**Re: PLANNING APPLICATION NO CE/13/01667/FPA**

**Conversion and extension of Neville House and demolition and replacement of Sheraton House to form student accommodation development comprising a total of 424 no. beds and associated works and landscaping.**

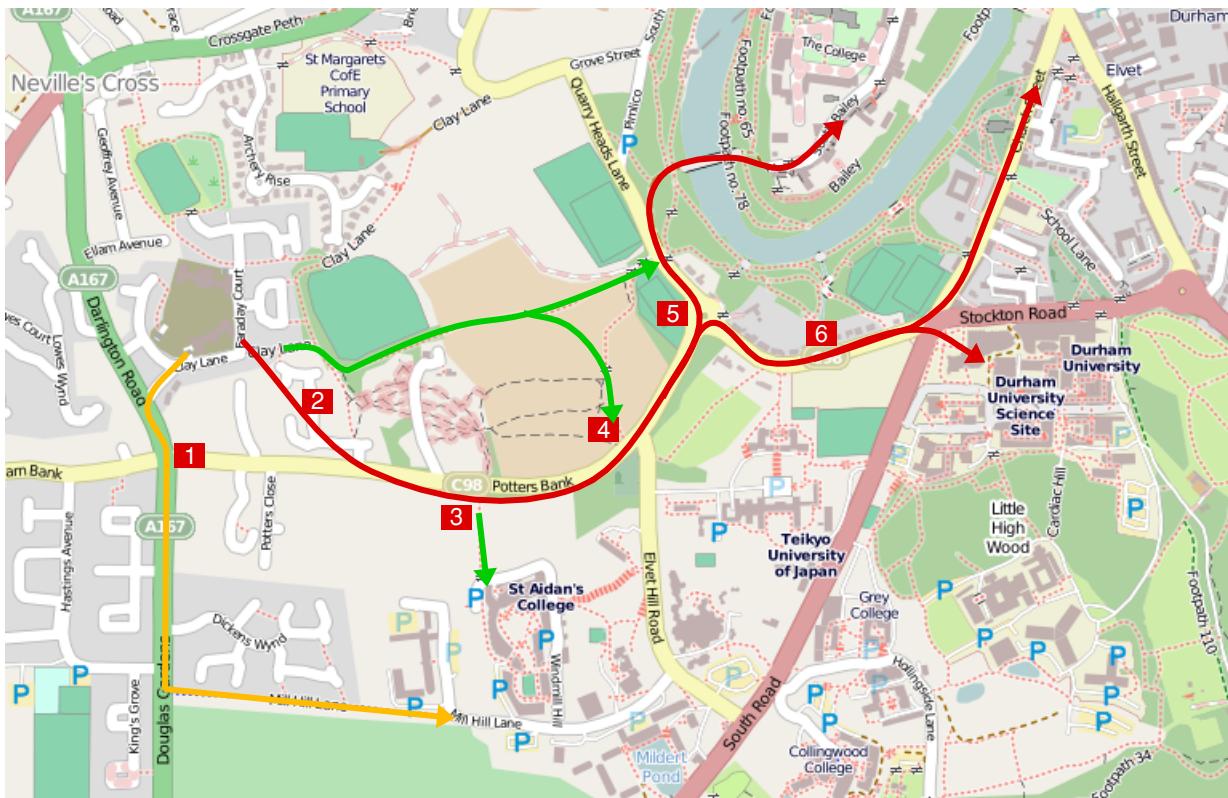
The map above shows the most direct routes available at present by bike to different parts of the university. The orange line leads to the Business School and some of the Hill Colleges. The red line is the obvious route leading to the Bailey via Prebends Bridge, the lower Mountjoy campus (science site) and via Church Street to the Elvet Riverside buildings and the Education / Hild-Bede campus via Baths Bridge. Elvet Hill Road offers access to colleges and the upper Mountjoy campus but for most buildings it is less direct than the combination of Potters Bank and Quarryheads Lane.

The main additional route available to pedestrians is that via the Observatory to Quarryheads Lane or the Potters Bank / Elvet Hill Road junction, and a footpath from Potters Bank to St Aidan's College (green arrows).

The route alongside the A167 is shared-use pavement, i.e. a pavement with signs permitting its use by cycles and no demarcation between cyclists and pedestrians. At the Duke of Wellington crossroads (1) there is a toucan crossing for north-south travel on the shared-use pavement, but no obvious safe connections to the road network for cyclists to leave or join the route to head east or west.

The development is already connected to Potters Bank via Clay Lane and Westhouse Avenue, where bollards prevent through motor traffic (2). Alternatively the neighbouring footpath, FP127, leads from Clay Lane to Potters Bank avoiding the houses in Westhouse Avenue. This footpath is often muddy and would need upgrading if it were to serve as the main route for pedestrians.

A particularly bad spot is the junction with Elvet Hill Road (4). Cyclists turning right from Potters Bank into Elvet Hill Road have to approach with caution as it is not possible to see vehicles ascending Potters Bank until the last moment. We are thus vulnerably placed in the middle of the lane and at risk of being struck from the rear by a speeding car. It is similarly

When travelling east to west on Potters Bank the cyclist encounters different issues. On the lower stretch (between (5) and (4)) cyclists travel slowly up the steep hill, with any cars following being impatient to overtake. The situation is made uncomfortable by a long row of car parking spaces. If any of these are occupied, cyclists have to move out into the middle of the lane and the likelihood of aggressive or risky overtaking by drivers is increased. It would be very helpful if these parking spaces could be abolished and be replaced by double-yellow lines and a mandatory uphill cycle lane of a good width. As there are no adjacent properties it should be possible to abolish the parking spaces without serious objections. West of Elvet Hill Road it would be useful to provide an on-road advisory cycle lane, which would be possible within the existing road width, because having rushed up the hill cars are often forced to queue for the traffic lights and a considerable tail can build up. A cycle lane here would allow cyclists to continue safely past the queues. There is currently a tendency for cyclists to take to the pavement instead, which causes nuisance for pedestrians. Safety improvements, reduced speed, and cycle lanes would help mitigate this.

The roundabout at the foot of Potters Bank (5) is large and easy for cars to negotiate at speed. The approaches are wide enough for two lanes to form entering the roundabout. These features make it much more dangerous for cyclists and our members have experienced near-misses at this roundabout. The pedestrian refuges for crossing are also very small and inadequate for the high level of foot traffic. It is futile trying to reduce speeds solely by educating motorists. Highway engineering plays the biggest part. Tightening the corners at this roundabout and reducing the widths of the approaches to prevent two lanes of traffic forming will improve the safety of vulnerable road users, both cyclists and pedestrians.

The final section of the journey to the Mountjoy campus along Quarryheads Lane (6) can also be quite hostile at times. Again, speeding can be a problem, with cars rushing to beat the traffic lights. The total width available here, with adequate pavements, grass verges, wide carriageways and a line of parking spaces on one side would permit the provision of a bidirectional segregated cycle lane on the Dutch model. The current Durham cycling strategy aspires to follow the best UK and Dutch standards, with the CROW cycle facilities manual being mandated. The volume of cycle traffic along this route would fully justify such provision, and it would assist with promoting cycling to local schools. If this option were adopted then the authorities should also consider abolishing the roundabout and connecting the cycle lane directly with the route to Prebends Bridge.

- Widening the shared-use path along the A167 south from the development.
- Measures to reduce incidence of speeding on this section of road.
- Retiming of traffic lights at Duke of Wellington junction to allow more time for west-east cycle traffic, together with better access to/from the A167 cycle path.
- Junction improvements at Dickens Wynd (A167) to give priority to cyclists and pedestrians.

- Extending pavement round the corner from Westhouse Avenue to assist pedestrians in crossing Potters Bank.
- Removing parking spaces from the lower part of Potters Bank (from Elvet Hill Road to the roundabout) and conversion to an uphill 'crawler lane' for cyclists.

- Provide on-road west-bound cycle lane on Potters Bank all the way to Duke of Wellington junction to allow cyclists past queuing traffic.
- Speed cushions, or junction realignment, to improve the safety of the Potters Bank / Elvet Hill Road junction.

- Redesigning the roundabout at the foot of Potters Bank to reduce speeds, increase the size of pedestrian refuges, and improve safety for cyclists.
- Provision of a bi-directional fully segregated cycle route along Quarryheads Lane from the roundabout to the New Inn junction, together with an 'all green' phase for pedestrians and cyclists to give easy access to and from the University campus.

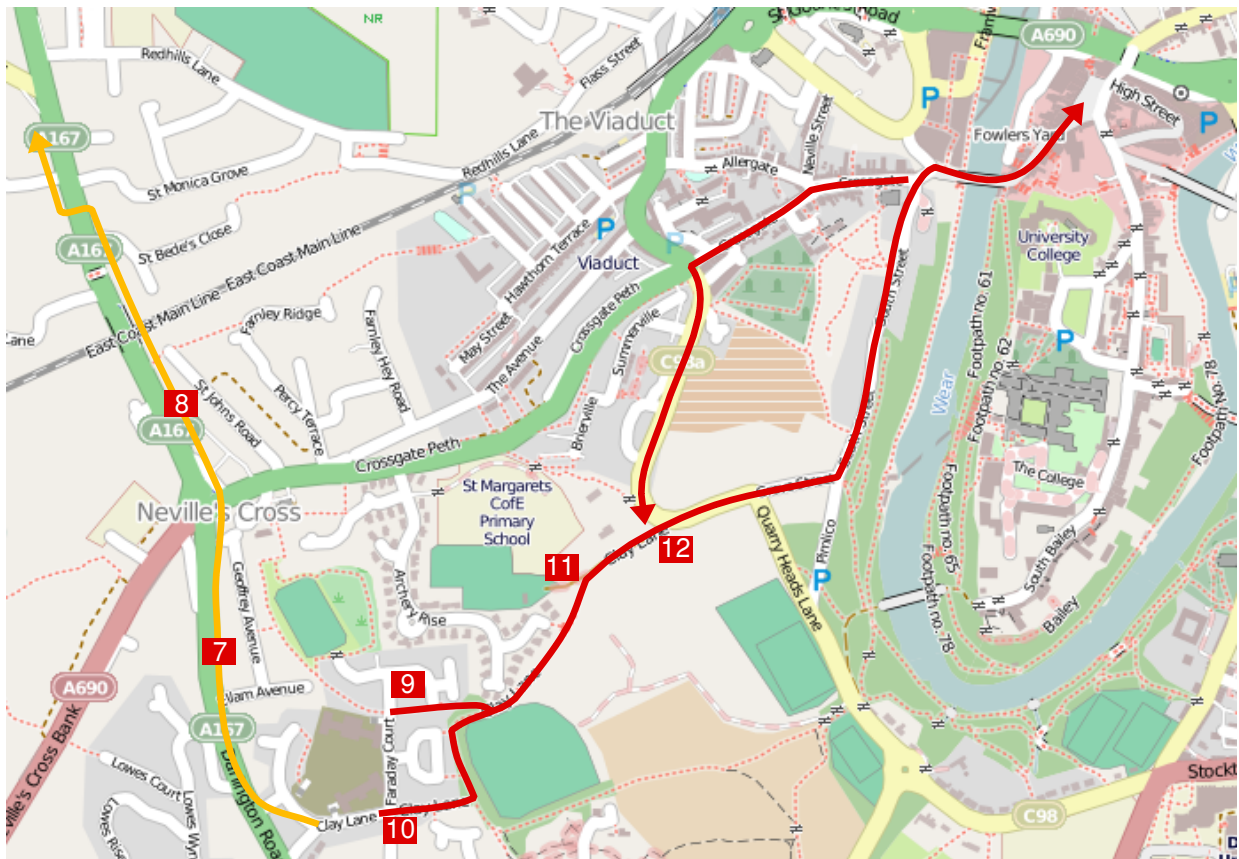
The following map concentrates on routes to shops and the city centre. A new supermarket is proposed to open on the A167 in Crossgate Moor. If promoted to the residents it could prove

popular because of the shorter distance and the relatively level route to access it. This is the route marked in orange.

The most direct route to the town centre is that shown in red. The route into town, via Clay Lane and South Street, is entirely along footpaths or quiet residential roads. But as South Street is currently one-way for all vehicular traffic including bicycles, students would have to return via Crossgate and Margery Lane, a much busier route, with a dangerous right turn to gain access to Clay Lane.

Note that Clay Lane is currently not officially open to bicycles, but is really the most practical route from the development into the town centre, and upgrading this route for shared use would benefit a lot of residents south of Neville's Cross.

- by the car hire outlet (7), south of Neville's Cross junction, where there are often cars parked on the driveways, blocking the pavement;
- approaching Neville's Cross junction from the south, with narrow pavements and railings reducing the effective width near the pedestrian crossing;
- continuing north from Neville's Cross, where the route is again very narrow with railings near the end of George Street (8).

Thus we would suggest that upgrading Clay Lane, currently a public footpath, would be the best solution to providing a cycle route to the town centre. It is already wide enough for much of its length. The surface could do with improving in a number of places. Access could be from the Neville House end of the site (9), via the existing footpath (FP11), which might need widening

At (11) the footpath meets the drive to the tennis club. From there to Margery Lane (12) the surface could do with considerable improvement. We understand it is currently maintained *ad hoc* by the tennis club. As Margery Lane approaches, a couple of paths diverge from the main drive. These could also do with better surfacing and maintenance as they are frequently muddy.

The most serious issue with this route is the junction with Margery Lane. Although a footway continues on the south side of the road on the Durham School side, the pavement going north gives out as the Blind Lane footpath (FP18) turns off. Pedestrians have a tricky road crossing to make on a blind bend.

- Upgrading the shared-use provision north along the A167 as far as the planned supermarket in Crossgate Moor.

- Upgrading Clay Lane from the development to junction with Margery Lane: widen the path where necessary and improve the surface, especially on the tennis club drive and the muddy paths approaching Margery Lane. Opening the whole route to cyclists as a shared-use path.
- Margery Lane, between the entrances to Briardene and Clay Lane, to be closed to through motor vehicle traffic, or alternatively, strong measures to improve the safety of the Clay Lane / Margery Lane junction for pedestrians and cyclists.
- Opening South Street two-way to cycle traffic.
- Reopening Framwellgate Bridge and Silver Street two-way to cyclists, at least during the times when deliveries are permitted, outside peak shopping hours.
